**Drain:** PARKS AT SPRINGMILL DRAIN      **Drain #:** 294  
**Improvement/Arm:** PARK MEADOWS - SECTION 5  
**Operator:** JOH      **Date:** 2-23-04  
**Drain Classification:** Urban/Rural      **Year Installed:** \_\_\_\_\_

RE: The Parks @ Springmill Drain-Park Meadows-Section 5 Arm

Re: Parks at Springmill: Park Meadows Sec. 5

THE ESTRIDGE GROUP  
THE PARKS AT SPRINGMILL  
SECTION 5

Sheet No.  
**C602E**  
JUL 14 1997

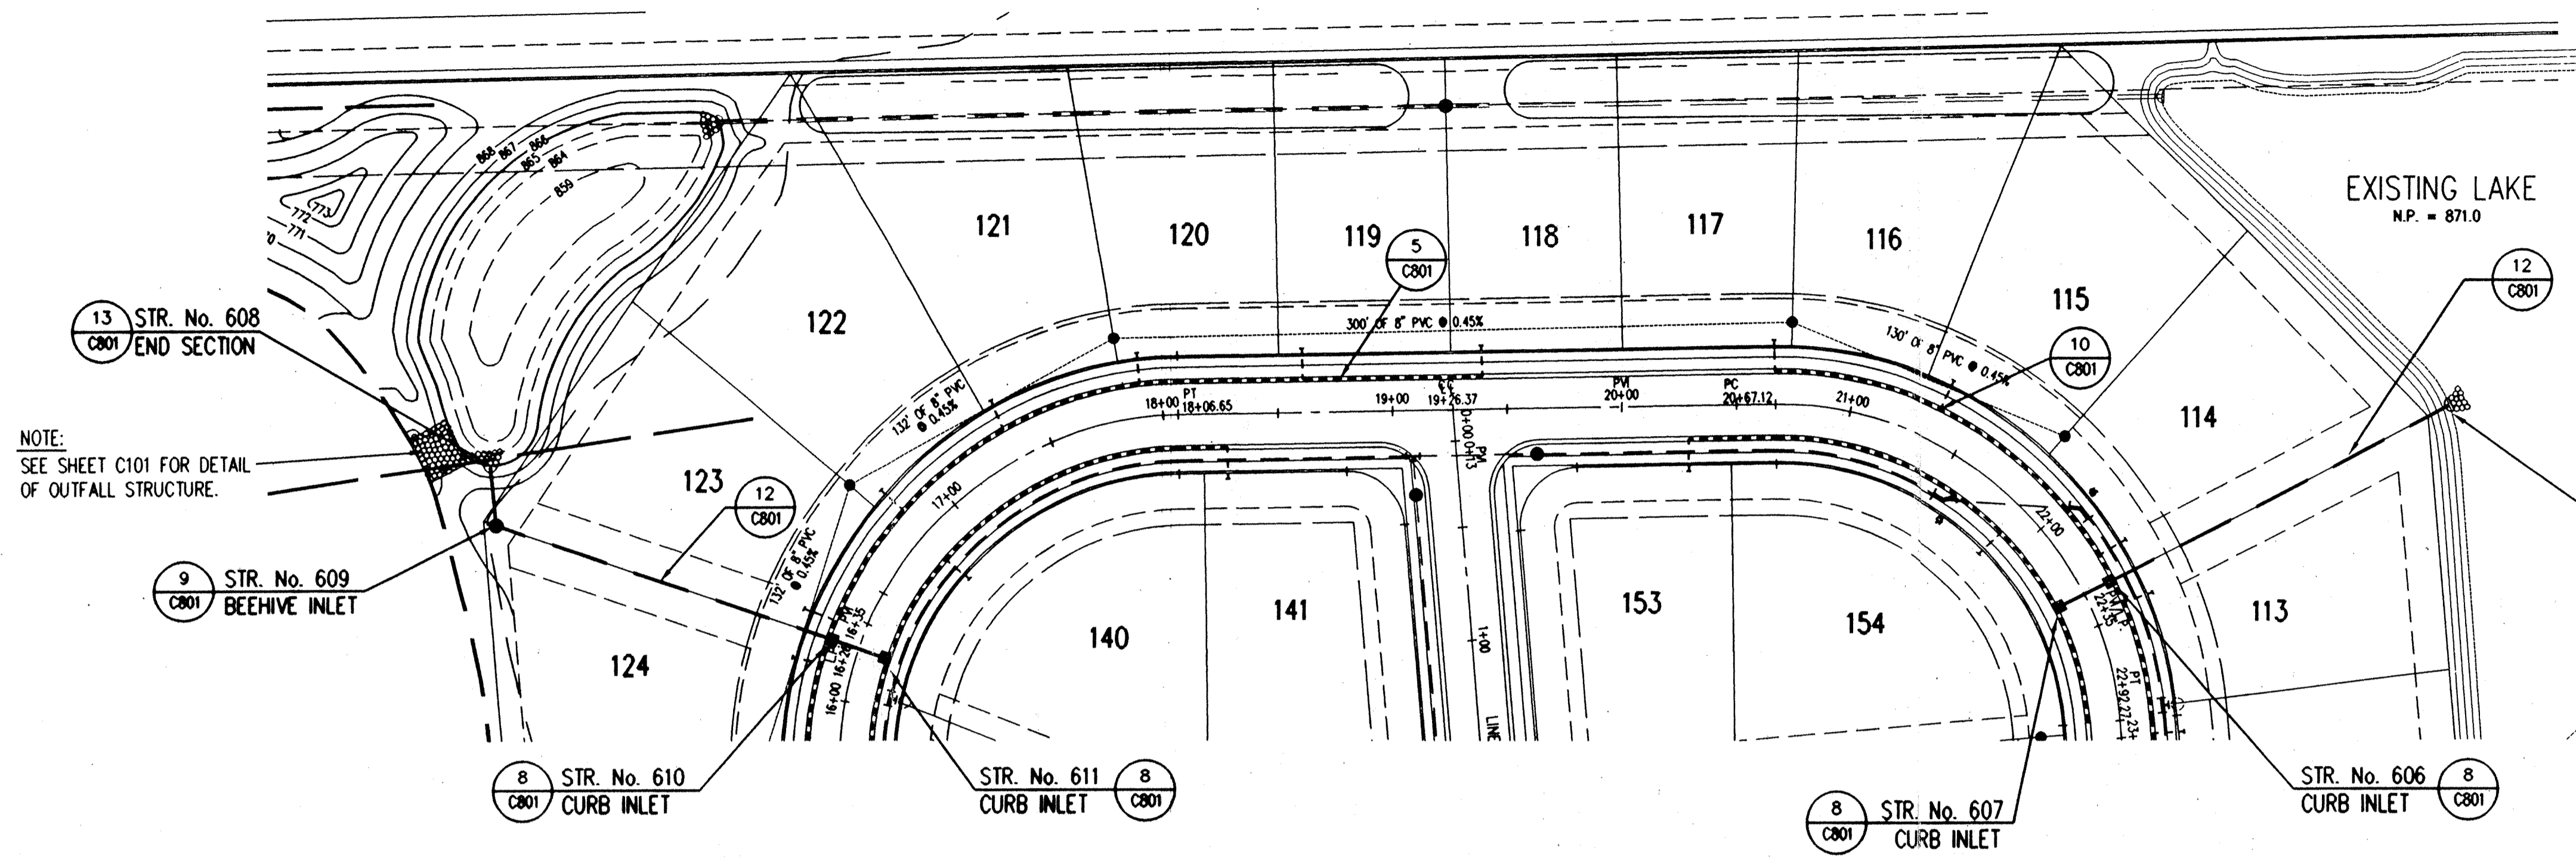
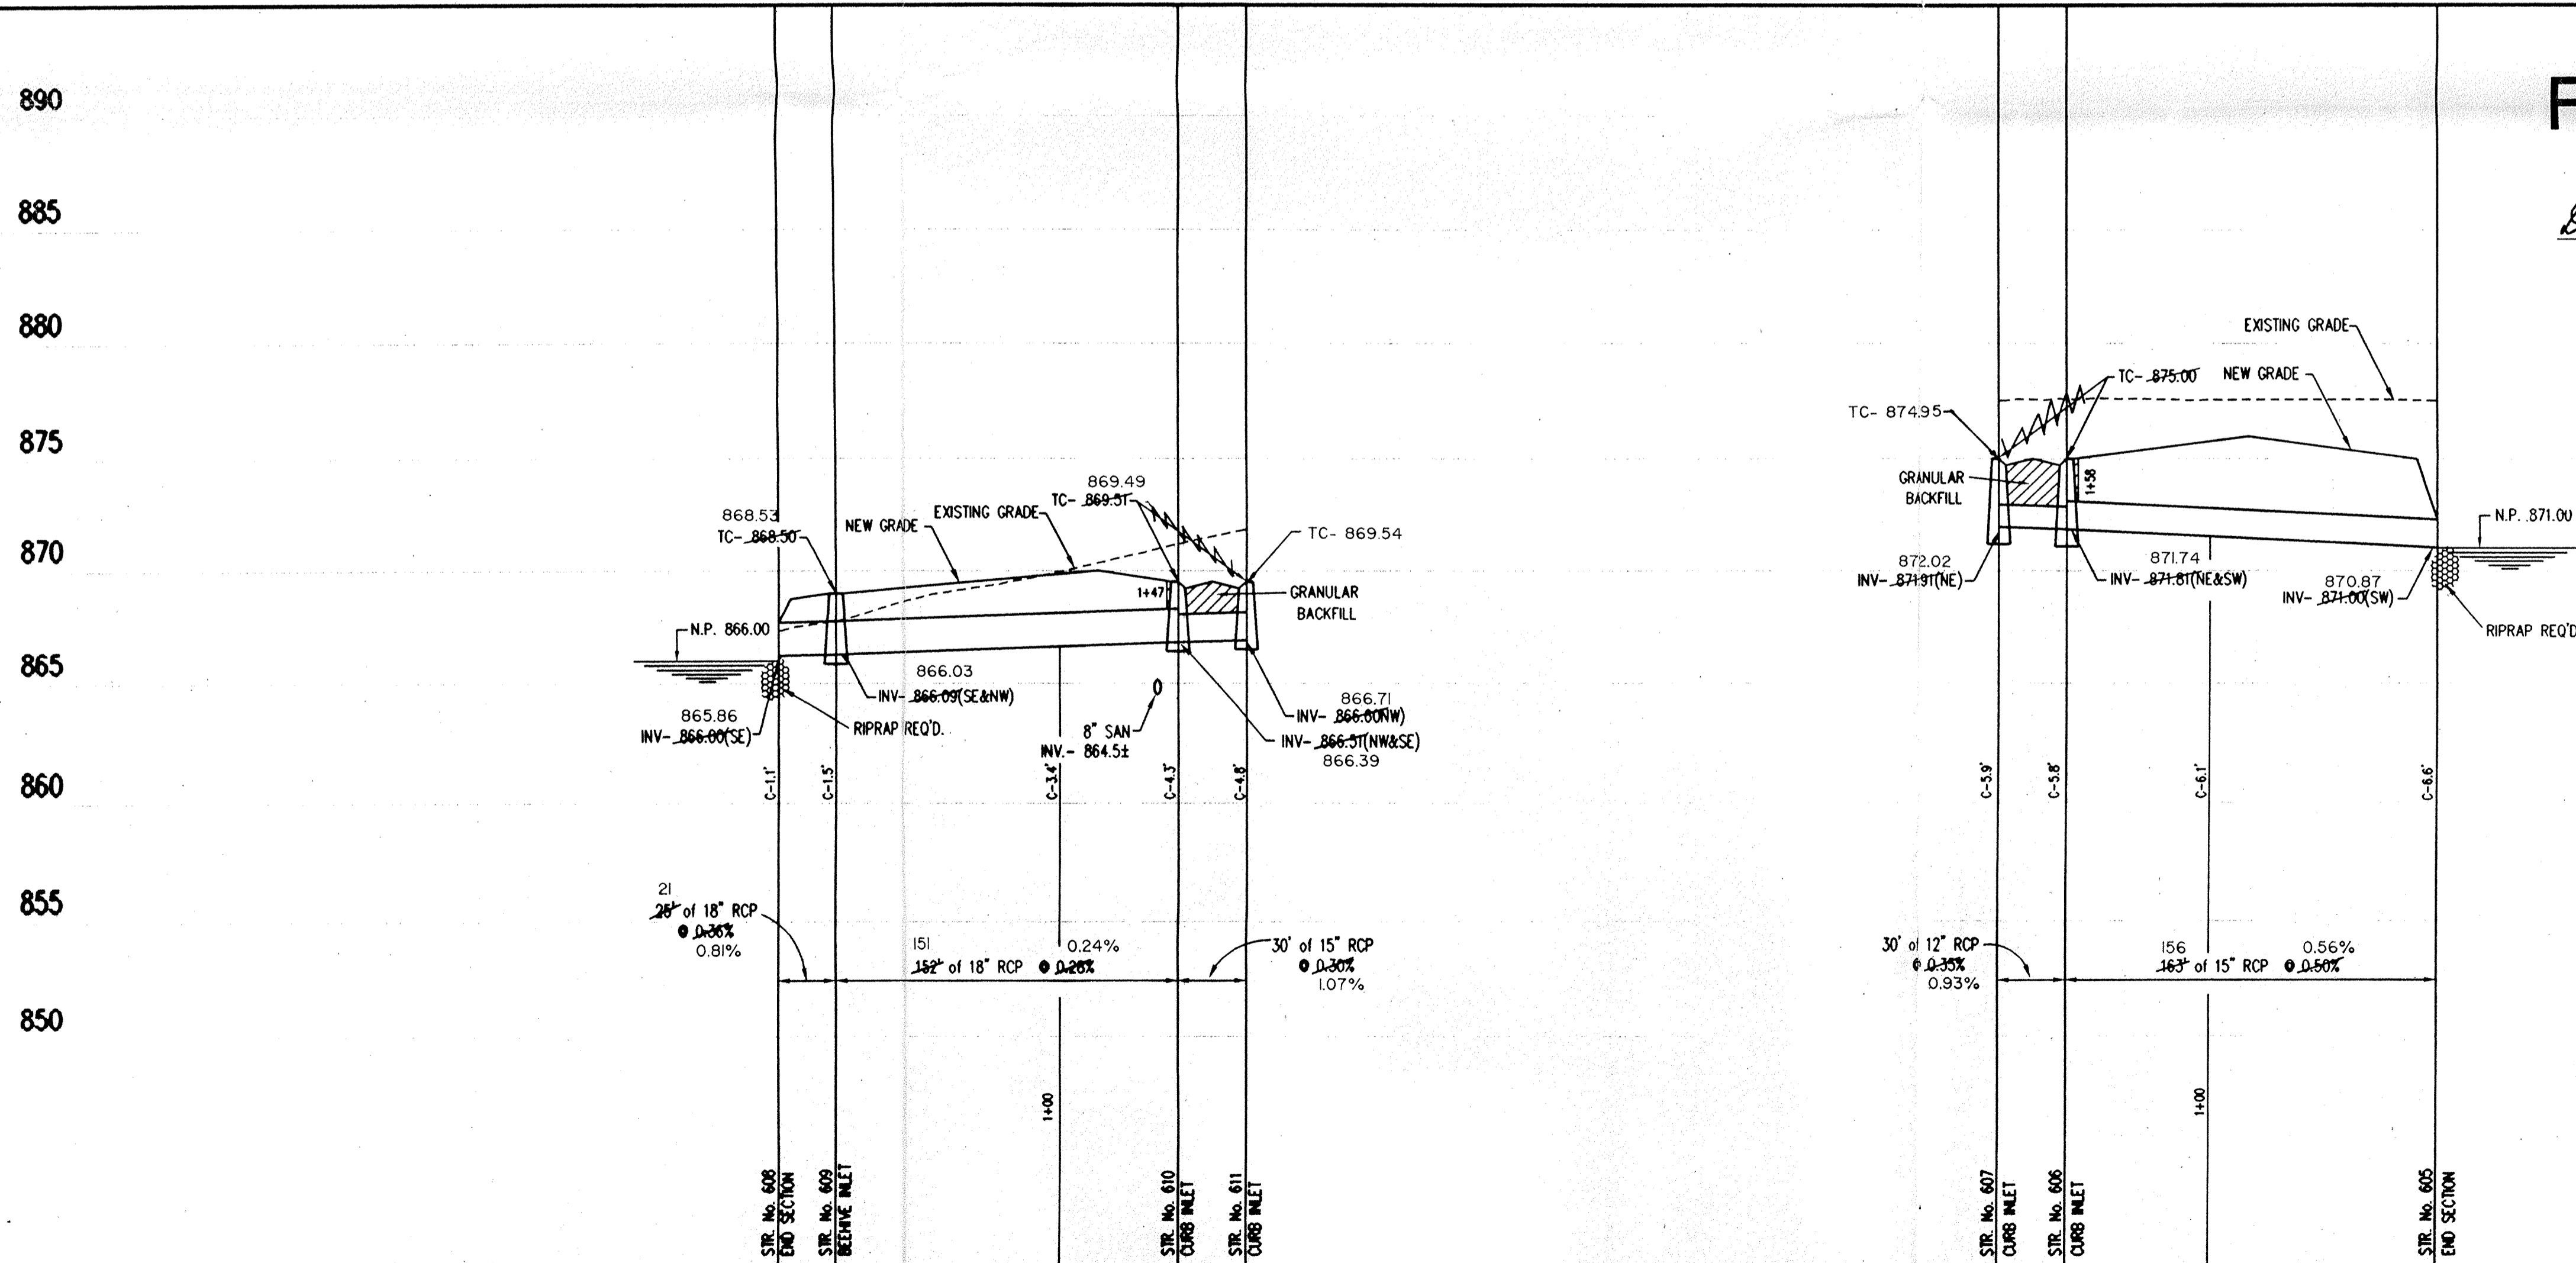
Revisions  
1. 07/26/96 REVISED PER I.A.C. COMMENTS B.E.T.  
2. DEC 10/23/96: THE TC FOR STR. # 609 WAS CHANGED TO 868.50.  
ADDED THE STRUCTURE DATA TABLE.  
2-6-97 AS-BUILT'S KCS
